1 March 2021

Department of Planning, Industry and Environment
Major Projects

RE: OBJECTION LETTER TO BEACHES LINK AND GORE HILL FREEWAY CONNECTION

Figure 4. Predicted noise levels during the establishment of the flat rock drive construction zone
Source: Renzo Tonin and Associates

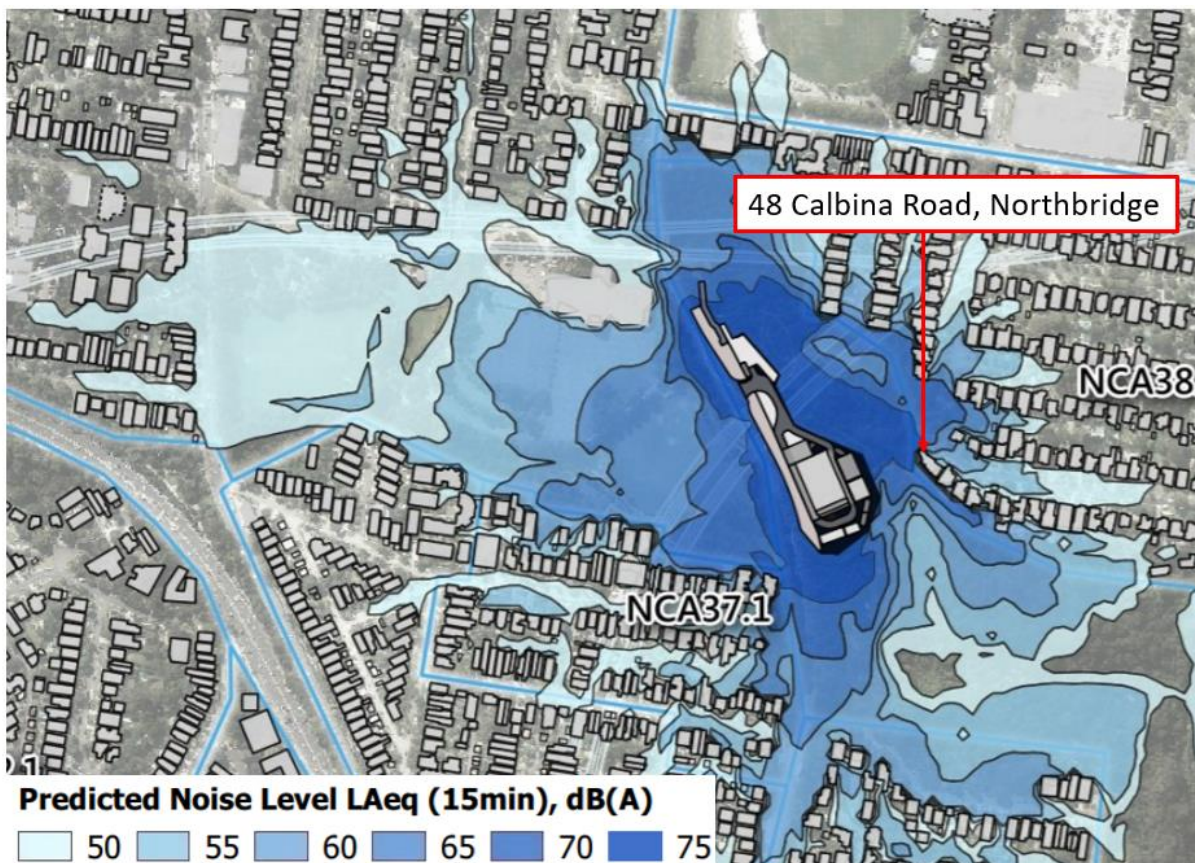
Figure 4 below illustrates the location of where the dwelling is relation to predicted noise levels during the establishment of the flat rock drive construction zone. The subject site at 48 Calbina Road, Northbridge is predicted as being subject to a noise level LAeq (15min) of greater than 75 DB(A), being the most severe acoustic impact on the noise level scale.

Figure 5. Predicted noise levels during the standard hours road widening of the flat rock drive construction zone
Source: Renzo Tonin and Associates

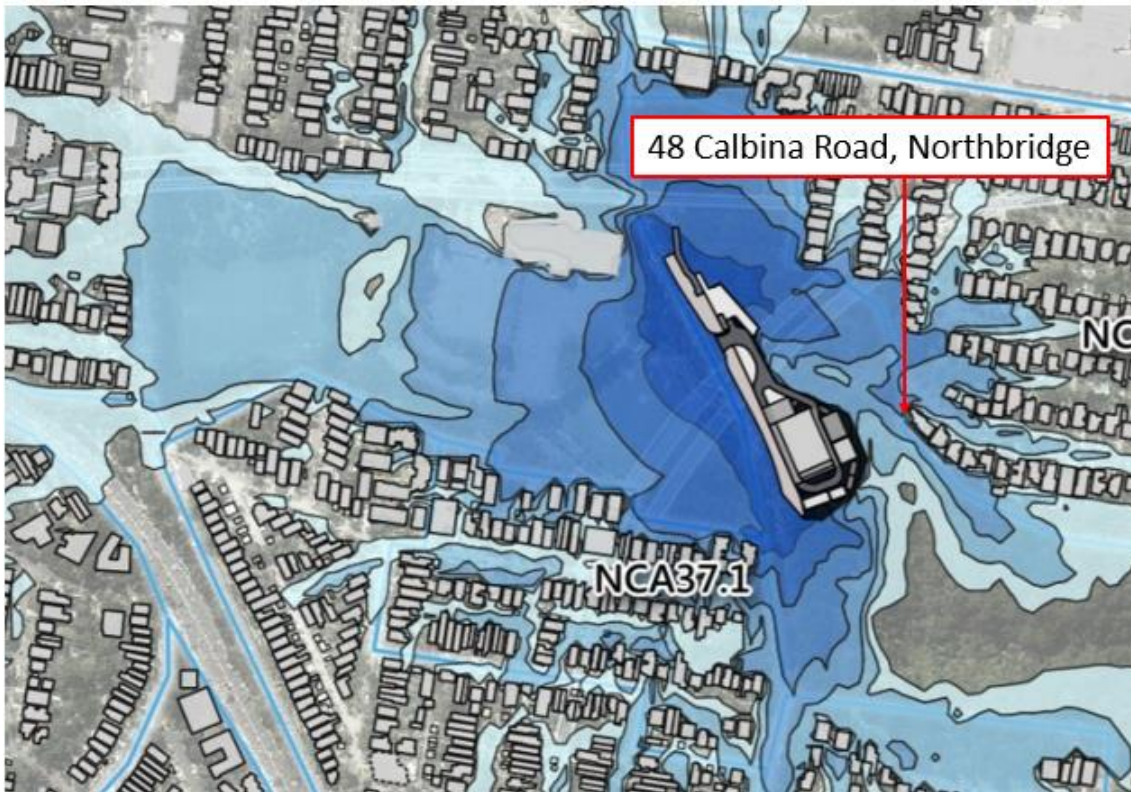
Figure 5 below illustrates the location of where the dwelling is relation to predicted noise levels during the standard hours road widening of the flat rock drive construction zone. The subject site at 48 Calbina Road, Northbridge is predicted as being subject to a noise level LAeq (15min) of greater than 65 DB(A), being a severe acoustic impact.

Figure 6. Predicted noise levels during the out of hours work road widening of the flat rock drive construction zone
Source: Renzo Tonin and Associates

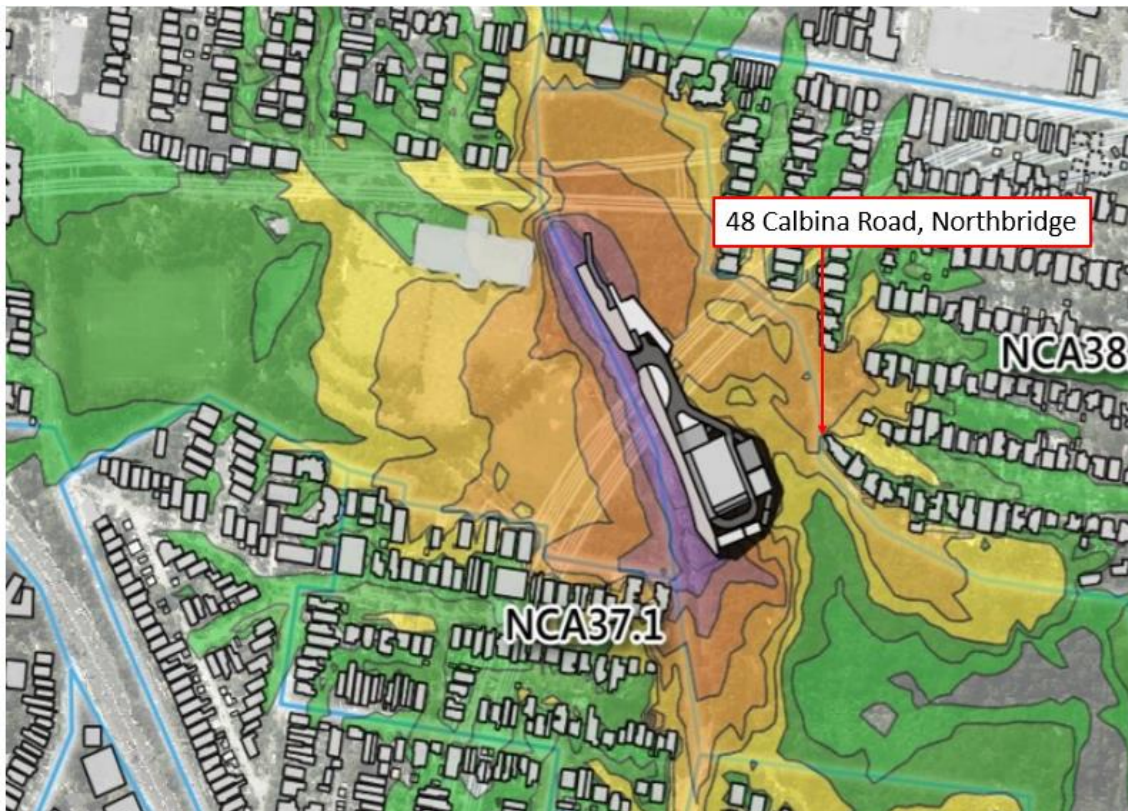
Figure 6 below illustrates the location of where the dwelling is relation to predicted noise levels during the out of hours work road widening of the flat rock drive construction zone. The subject site at 48 Calbina Road, Northbridge is predicted as being subject to a noise level LAeq (15min) of greater than 65 DB(A), being a severe acoustic impact.
